Iowa Department of Transportation
Office of Contracts Date

Date of Letting: February 17, 2015
of Addendum: January 28, 2015

B.O.	Proposal ID	Proposal Work Type	County	Project Number	Addendum
111	53-C053-077	PCC OVERLAY - UNBONDED	JONES	HSIP-S-C053(77)--6C-53	17FEB111.A01

L.1 updated drawing to show correct joint spacing's

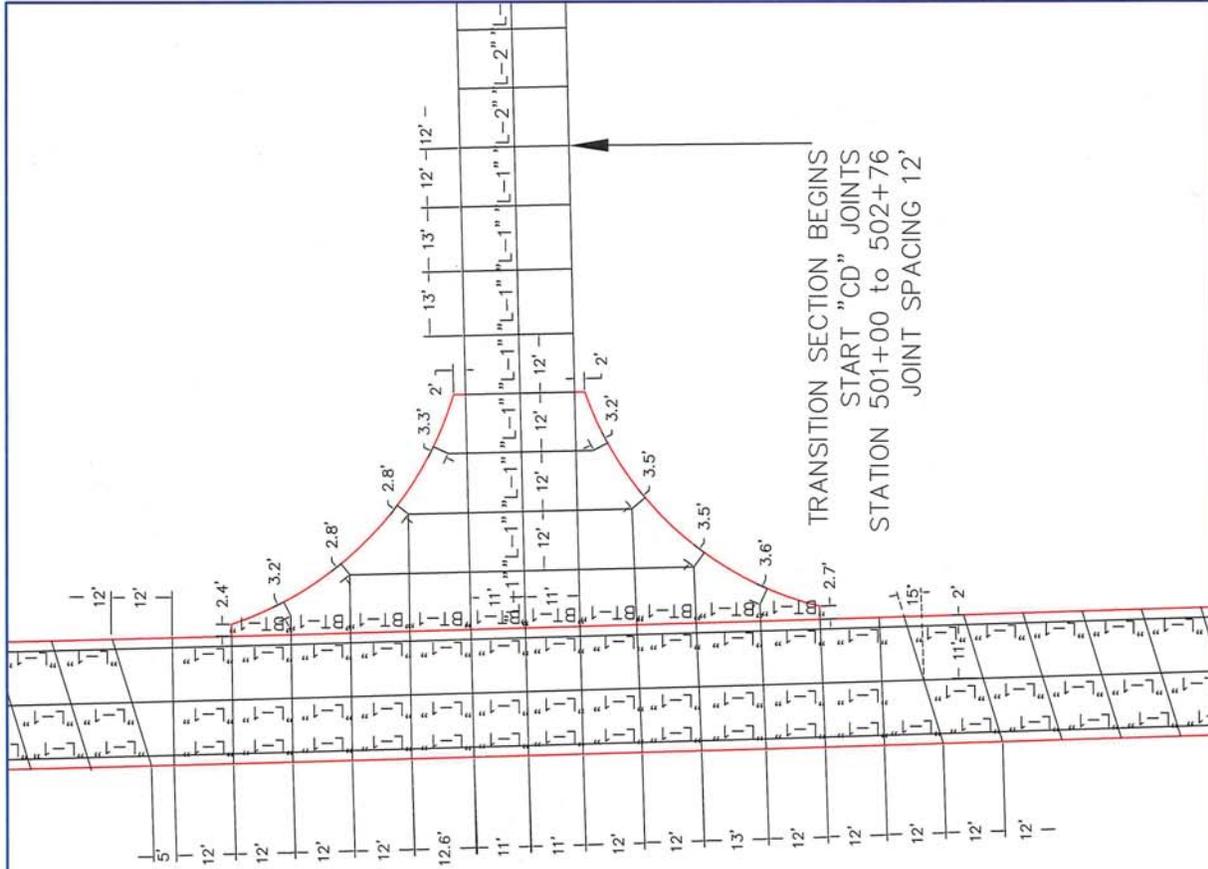
“JOINTS SHALL BE SAWN AT 12' SPACING UNLESS SHOWN OTHERWISE ON JOINTING DETAIL SHEETS L.1, L.2”

ENGLISH	JCED	DESIGN TEAM	Snead/Postel/Bertling	JONES COUNTY PROJECT NUMBER	HSIP-S-C053(77)--6C-53	SHEET NUMBER	L-2
---------	------	-------------	-----------------------	-----------------------------	------------------------	--------------	-----

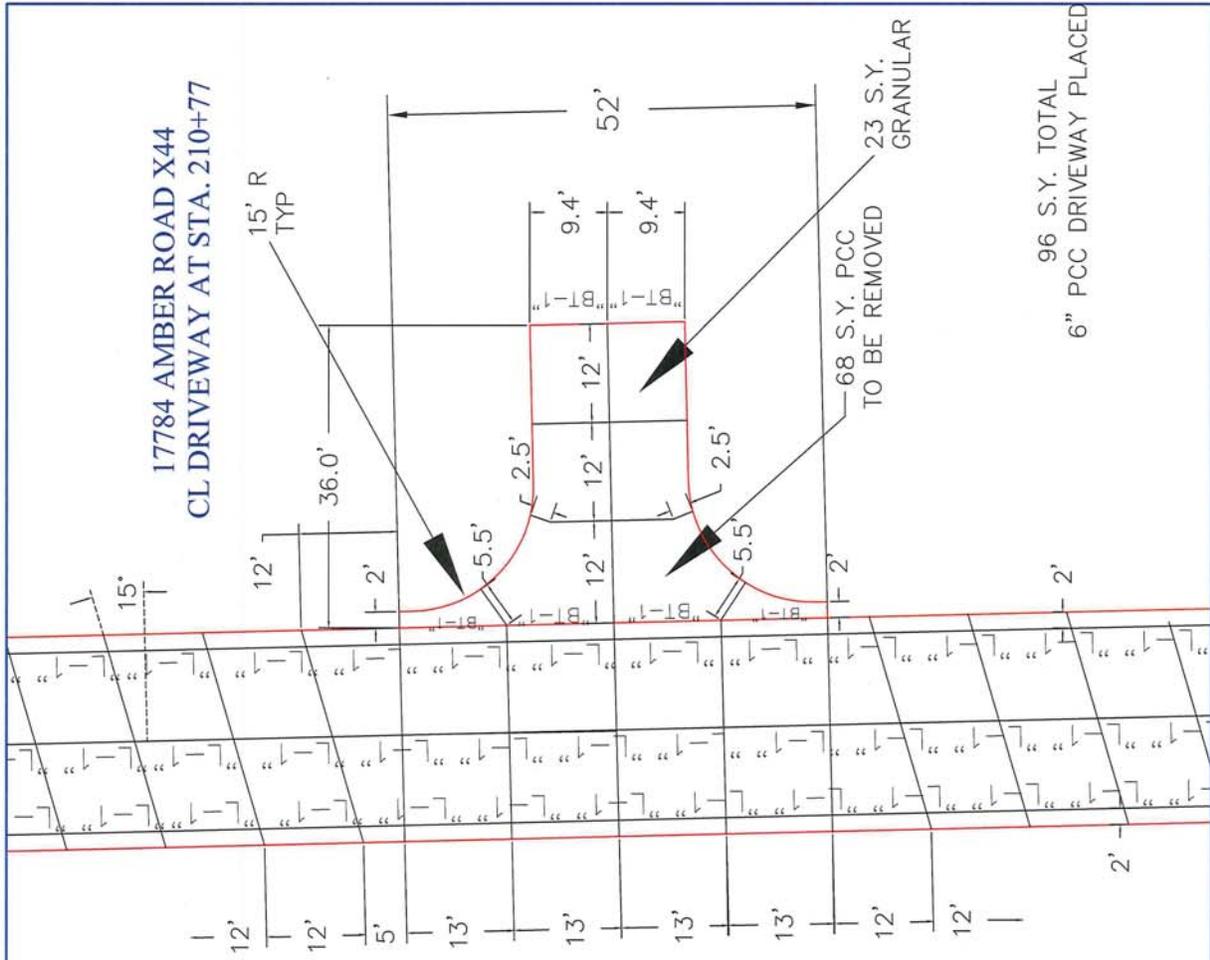
L.2 updated drawing to show correct joint spacing's
